ADDENDUM 4

BID TITLE: File No. 55-24 Green Road Pump Station

GREEN ROAD PUMP STATION– FILE NO. 55-24

ADDENDUM NO. 3

DRAWN BY: E. KLINE	SCALE AS NOTED	CWD NO:	SHEET NO:
DESIGNED BY: E. KLINE	DATE: 12/2021		E-06
CHECKED BY: J. SIDOTI

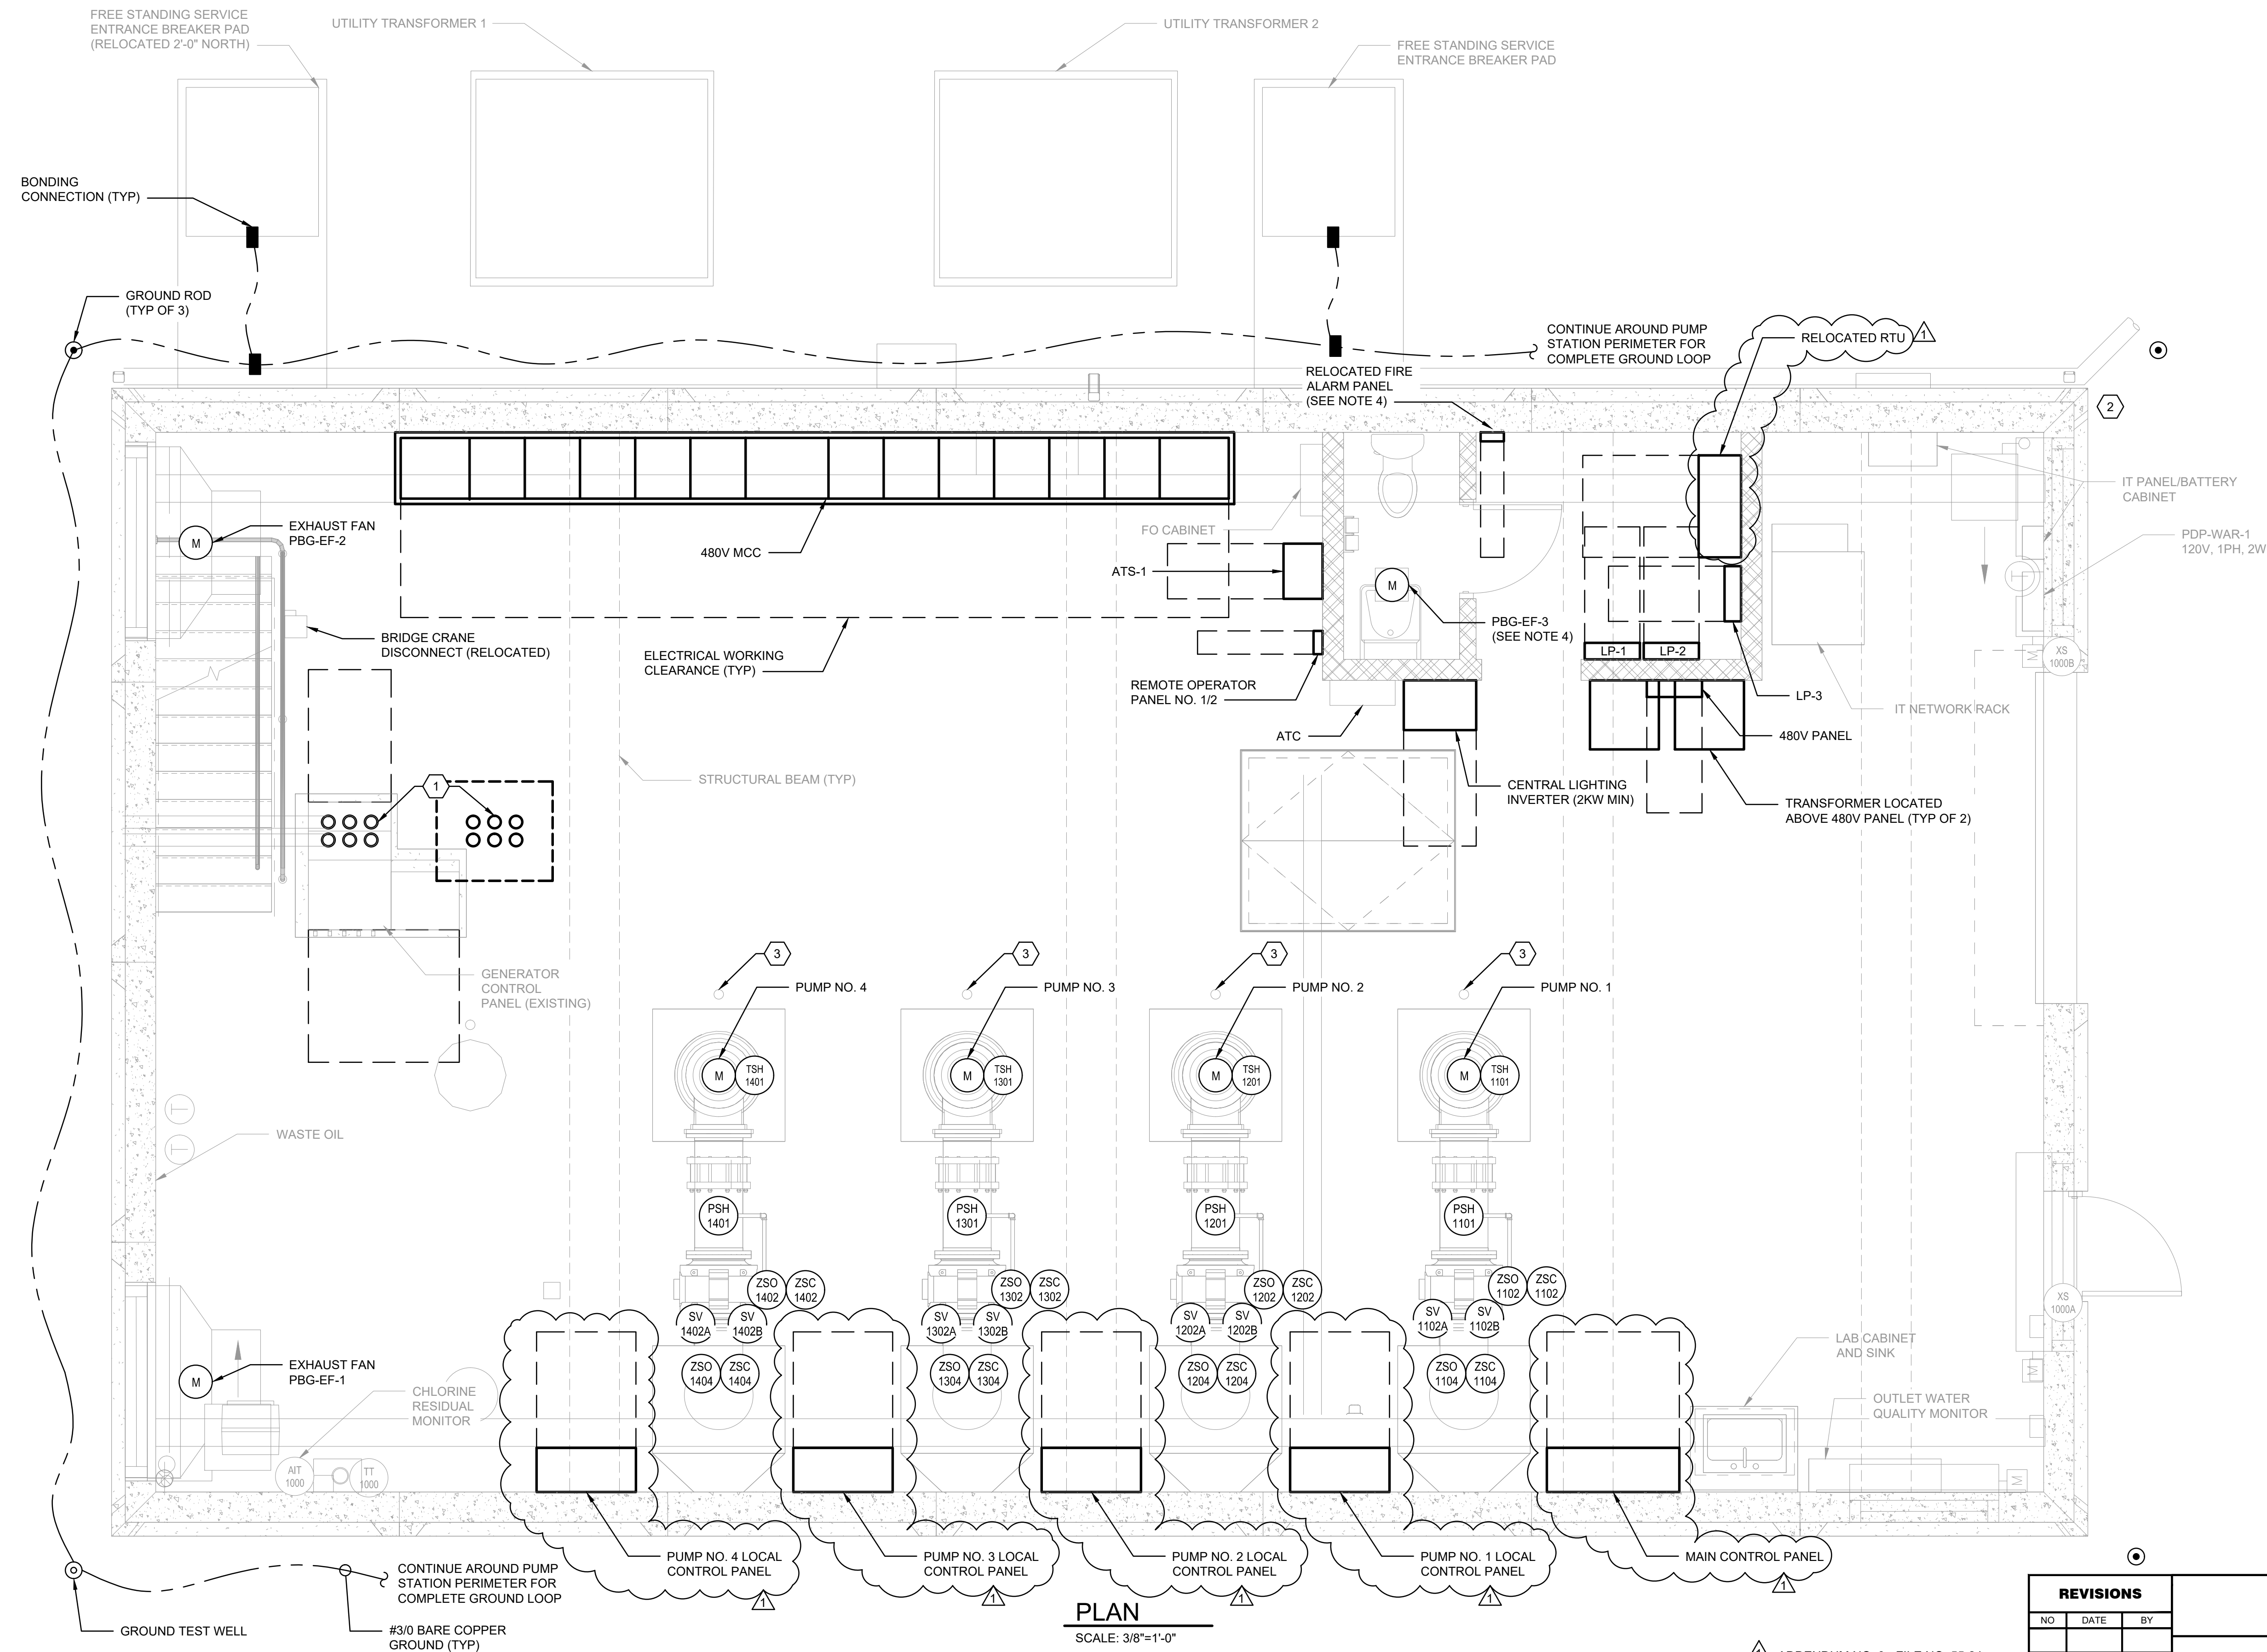
1. G-02: updated drawing index to indicate changes to numbers and titles of I sheets
2. C-03: updated to include concrete repair detail
3. E-06: updated to show the addition of the Local Control Stations (RIOs), the Main Control Panel (PLC), and relocated RTU
4. E-11: updated to show revised LP2 Panel Schedule for addition of four LCPs and updated Main Control Panel
5. E-12: updated to show revised conduit riser for addition of four LCPs and updated Main Control Panel
6. I-04 thru I-08: updated to indicate relocation of RTU panel and installation of new PLC panel
7. I-09 and I-10: new sheets with new pump Local Control Panel detail
8. I-10A and I-10B: new sheets with new Main Control Panel details
9. I-12, I-14 thru I-22: new/updated sheets to provide networking and loop drawings for new PLC panel and pump Local Control Panels
